Comments on EPA's Draft Report *MOBILE6 Inspection/Maintenance Benefits Methodology for 1981 through 1993 Model Year Light Vehicles, M6.IM.001*

**Submitted by Tom Wenzel, Lawrence Berkeley National Laboratory
July 27, 1999**

Figure 1. HC After Repair Adjustment Factors by MY
Proposed MOBILE6 vs. 1996-97 Arizona IM240

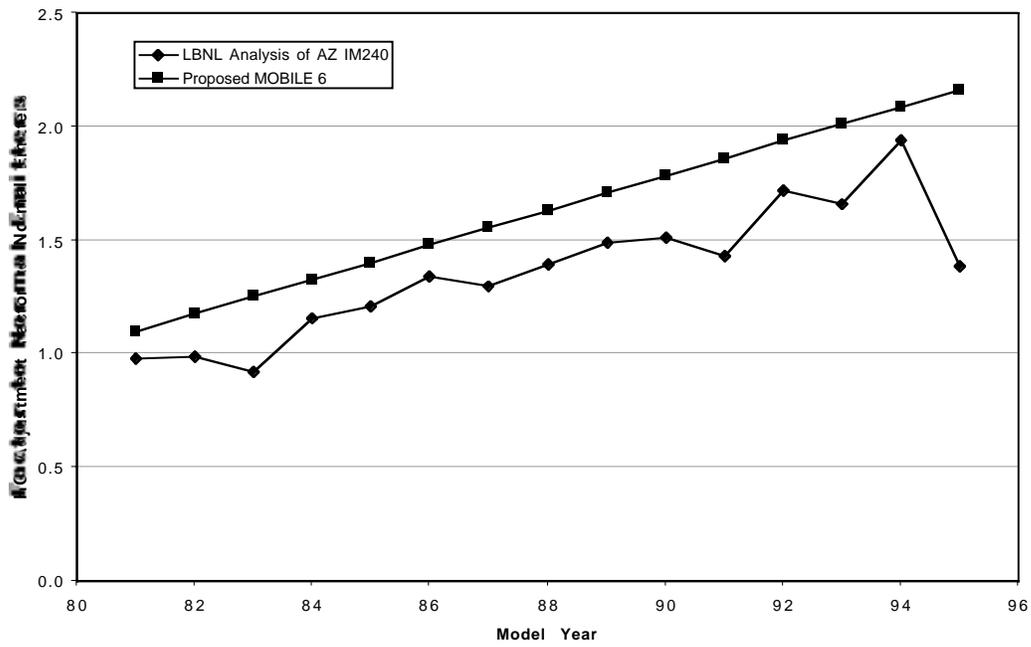
Comment: LBNL analysis of Arizona IM240 data finds the same result, that average emissions of seemingly repaired vehicles are not brought down to the level of vehicles that pass their initial test (Wenzel, 1999a). Figures 1 through 3 show the factors necessary to adjust average emissions of initially passing vehicles to the average emissions of vehicles that failed initial but passed final I/M testing in the Arizona program in 1996-97, compared with the factors EPA is proposing for MOBILE 6. In general the factors are quite similar, although EPA's factors are slightly higher, particularly for HC and CO.

Figure 4. Proposed MOBILE6 HC Deterioration Rates, Cars

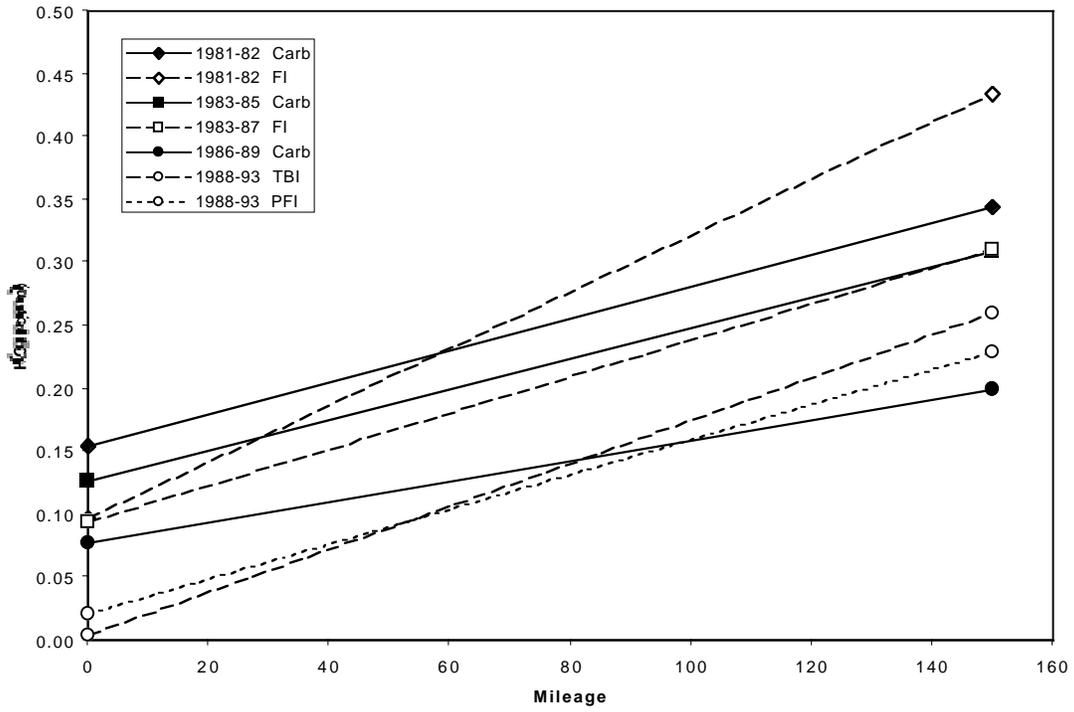
Comment: The curves for the different age groups of each fuel technology (FI and Carb) are roughly parallel (see Figures 4 through 9). However, all FI categories have higher slopes than all Carb categories. This means that at high mileages FI vehicles have higher emissions than carbureted vehicles. For instance, 1988-93 TBI and PFI HC emissions exceed 1986-89 Carb HC emissions around 80,000 miles (Figure 4). At 150,000 miles, HC emissions are: 0.26 TBI, 0.23 PFI, and 0.20 Carb. This does not make sense; a 1993 PFI is supposed to be much more durable than a 1986 Carb. If anything, the FI vehicles should have smaller slopes, in line with manufacturer claims (and evidence from IM240

data) that newer TBI and PFI technology vehicles have much less emissions deterioration than older FI and Carb technologies. In addition, for cars the CO PFI curve is much higher than the TBI curve. There is anecdotal evidence from some manufacturers that early PFI technology had problems to be worked out; however, this should not affect all years of PFI. The NOx deterioration rates for carbureted light trucks (Figure 9) have a very high intercept, and a very small slope. These rates suggest that these vehicles experience very little emissions deterioration as they accumulate mileage.
